**AMENDMENTS TO THE DRAWINGS**

## **REMARKS**

### **II. Objections to the Drawings**

FIG. 5

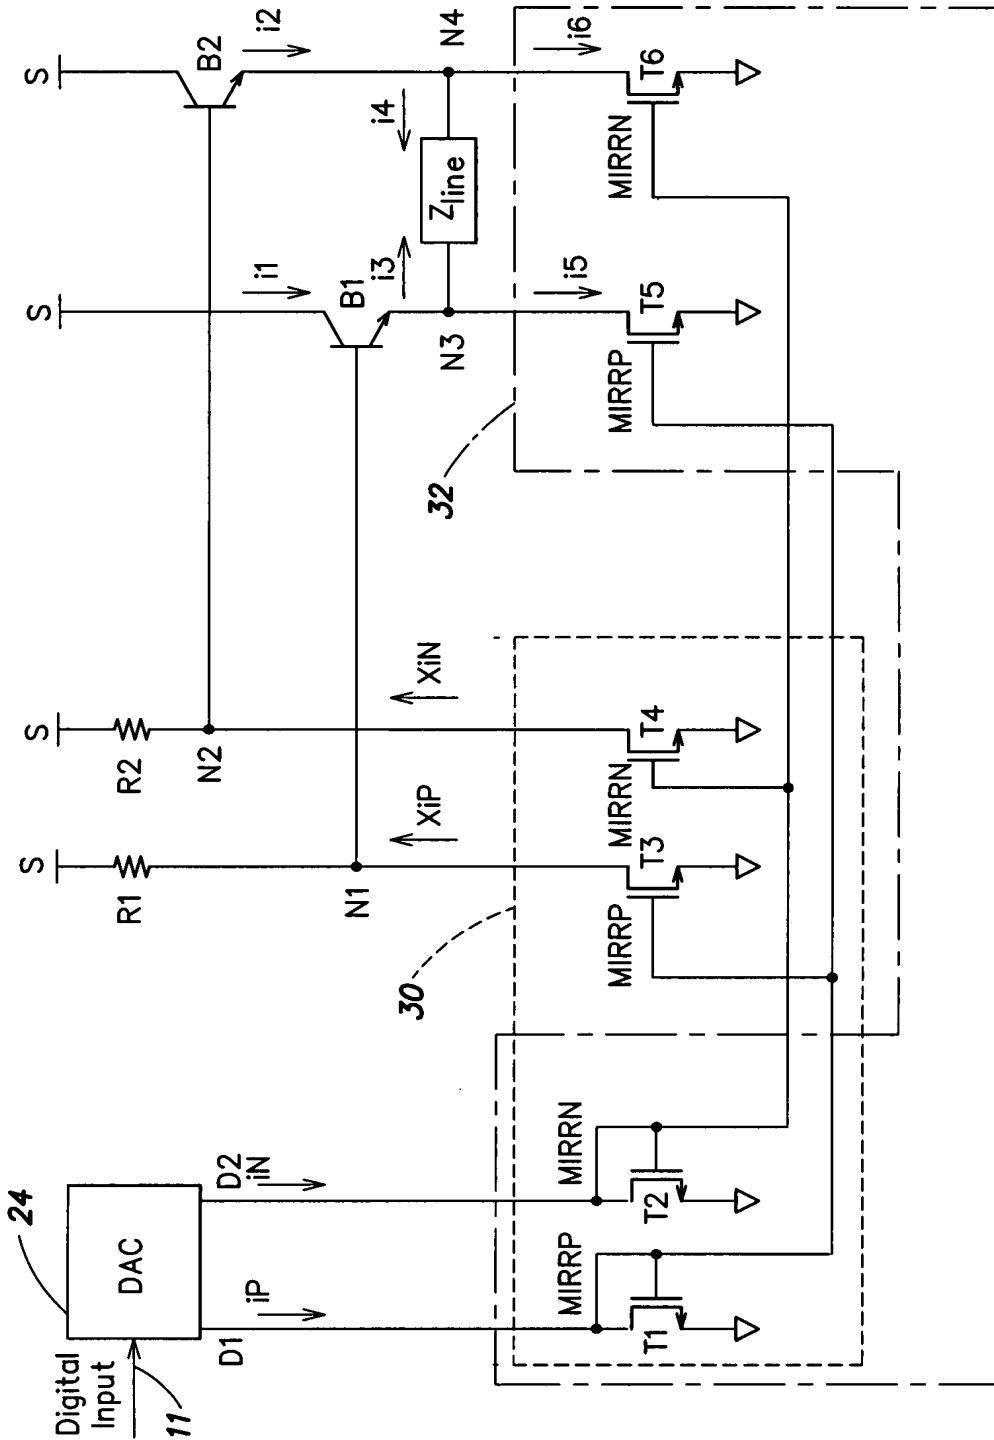
The Office Action objects to the drawings because the two current mirrors in figure 5 are allegedly unclear. Applicant has included herein a Replacement Sheet for FIG. 5. In the replacement sheet, the current mirror 30 and current mirror 32 are enclosed in respective differently patterned dotted lines to clearly distinguish the two current mirrors. The first dotted enclosure labeled as current mirror 30 encloses transistors T1, T2, T3 and T4 as described on page 5, lines 22

and 23 of Applicant's Specification. The second dotted enclosure labeled as current mirror 32 encloses transistors T1, T2, T5 and T6 as also described on page 5, lines 22 and 23. The two differently patterned dotted enclosures added in the Replacement Sheet now clearly illustrate grouping of transistors forming current mirror 30 and current mirror 32, respectively, as described in the Specification. Thus, Applicant respectfully requests that the objection to the drawings be withdrawn.
